Subject: Response to Submissions - Yiribana Logistics Estate (SSD-10272349)

Attachment 1: Environment and Heritage Group comments in relation to proposed stormwater management strategy for Yiribana Logistics Estate (SSD-10272349)

Attachment 2: Environment and Heritage Group comments in relation to potential alternative stormwater strategies for Yiribana Logistics Estate (SSD-10272349)

SSD-10272349 – Response to Submissions for Yiribana Logistic Estate

Stormwater Management Strategy (DesignFlow interpretation based on submitted information)

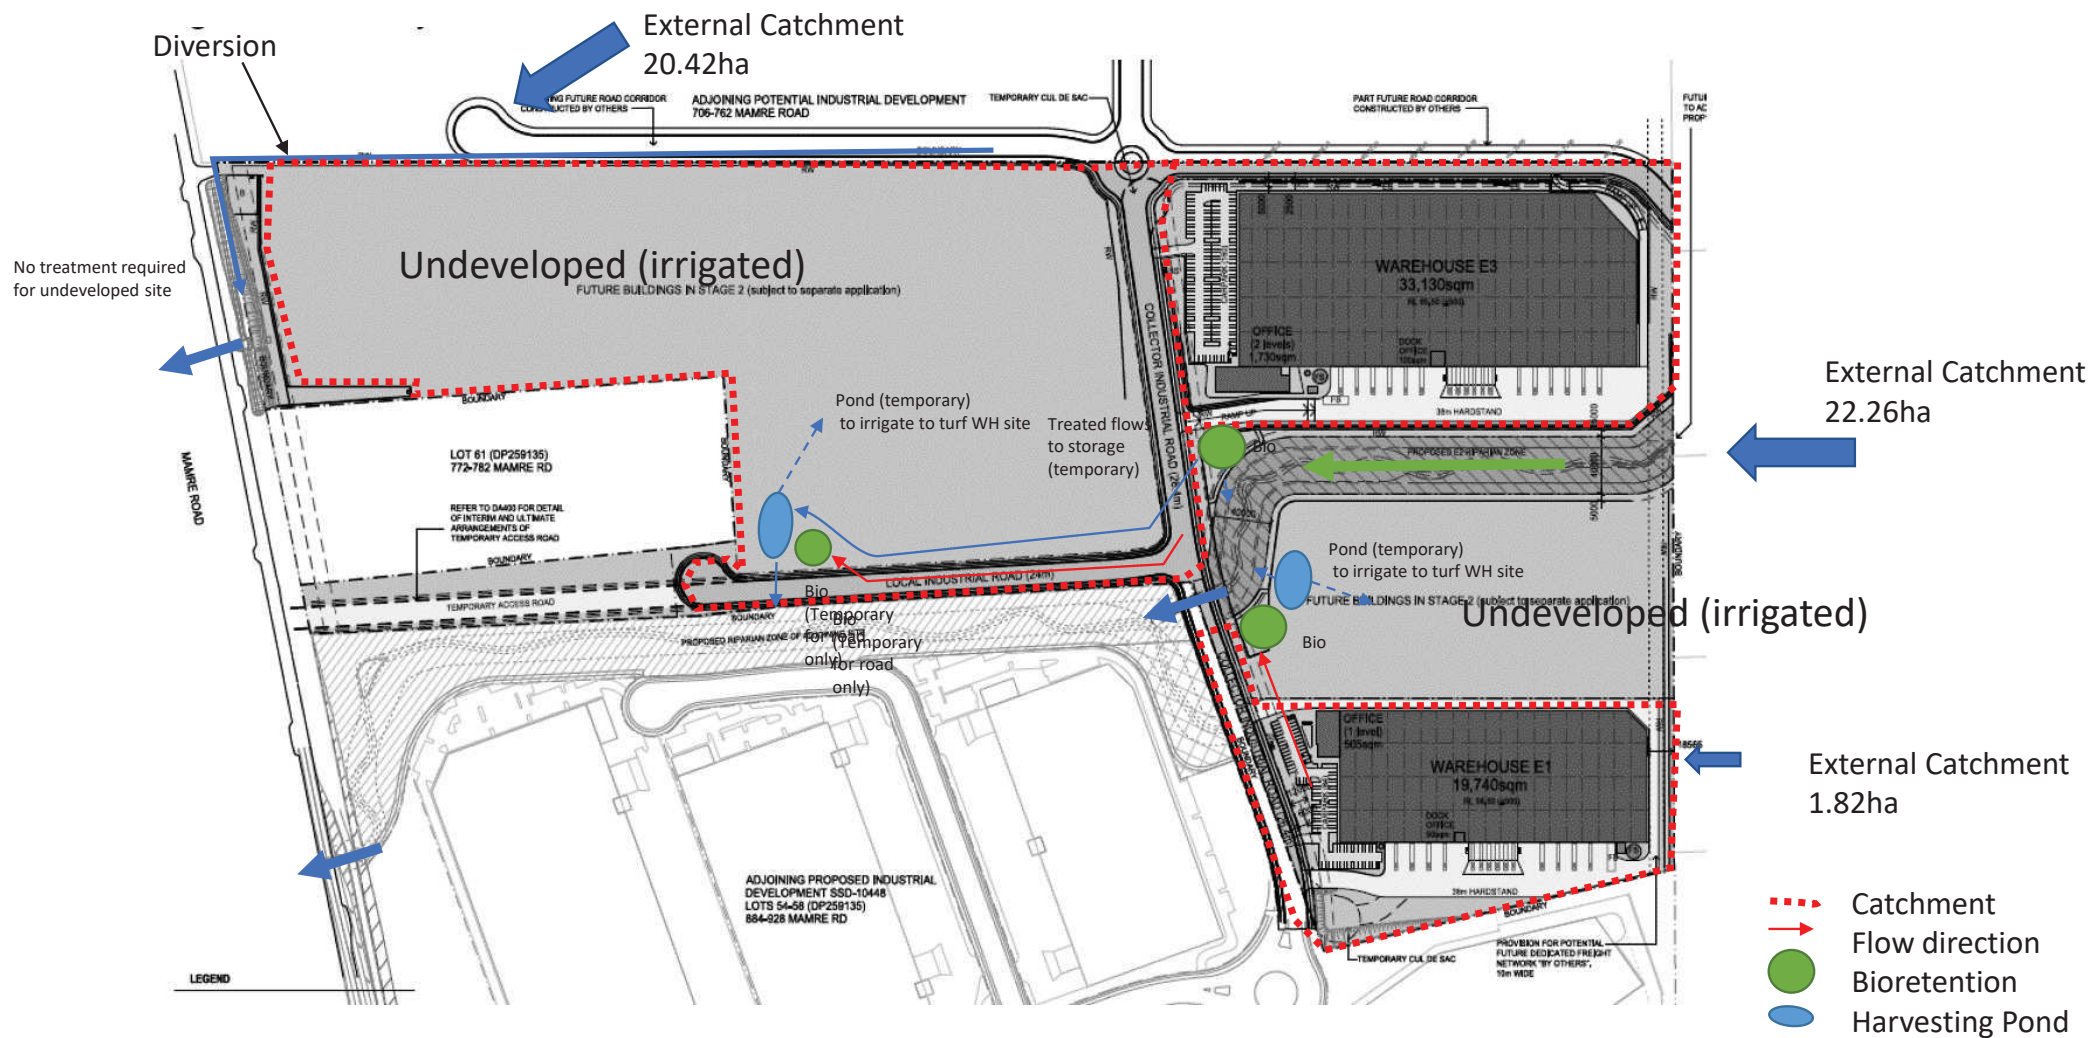
- The western 22.26ha external catchment enters the site into the proposed swale / waterway corridor and the online harvesting pond. Given the swale and pond are online to the external catchment, then this catchment needs to be included in the modelling. Currently the site is undeveloped but will ultimately be developed with WSUD. Both scenarios need be included in the strategy and modelling.

- The swale has been included in the MUSIC modelling to treat the development flows. However, development flows do not engage with the swale as they pass through the proposed bioretention systems and discharge to the proposed harvesting pond. The swale should be removed from the MUSIC model.

- To simplify the strategy and modelling, it is recommended that the harvesting pond is moved offline (refer potential alternative strategy at Attachment 2).

- It is unclear if the northern 20.42ha external catchment to the north has been modelled to confirm the diversion channel/pipe requirements.

Potential Alternative 1 Stormwater Management Strategy (suggestion only)

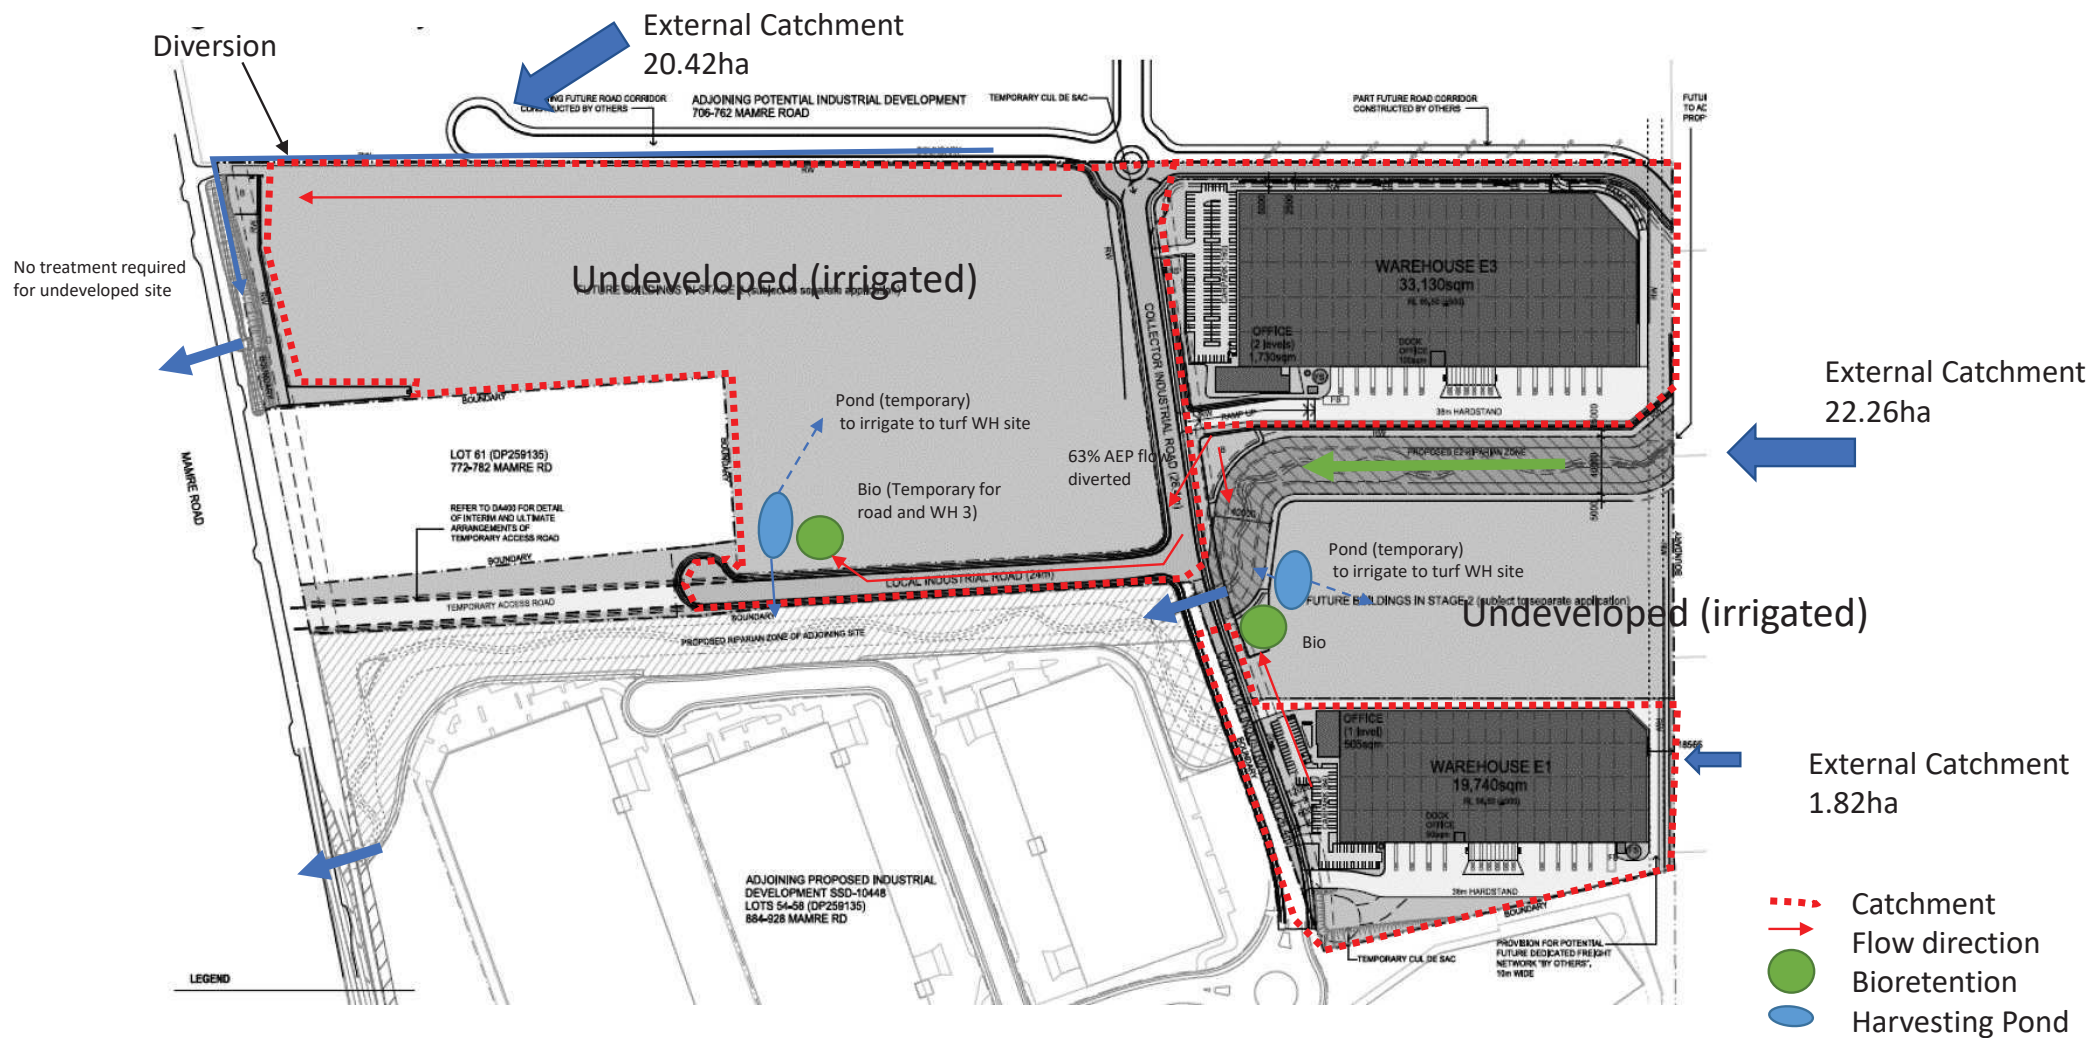
EHG notes that there may be alternative solutions for the implementation of a simple 'interim strategy' stormwater management strategy that does not require any change to the layout of roads, lots or warehouses. These potential alternative solutions are identified in **Attachment 2**. These solutions may also allow development of additional lots in the future.

EHG has engaged Design Flow to assist in the review of the stormwater strategy. Several potential alternative stormwater strategies for the proposal have been identified and attached for the consideration of the proponent.

OSD and Bio Basins located within corridor

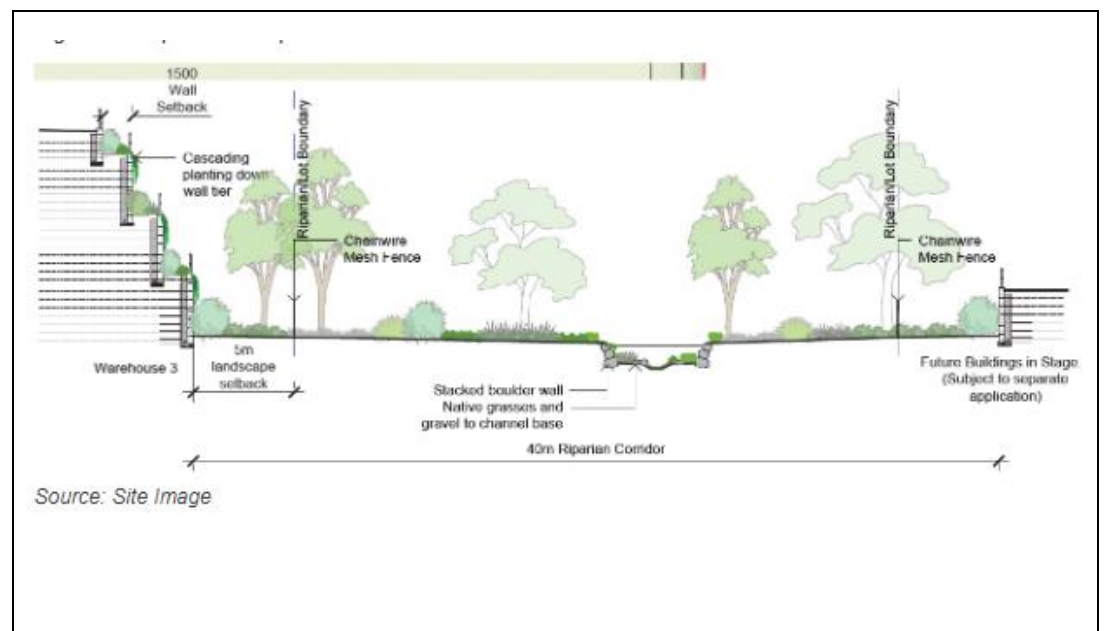
Civil plan no. SSDA432 indicates that Estate Basin 2, which is a combined OSD and bio basin is located in the corridor. DPE is to ensure that the corridor is for 'riparian' purposes and not OSD and trunk drainage.
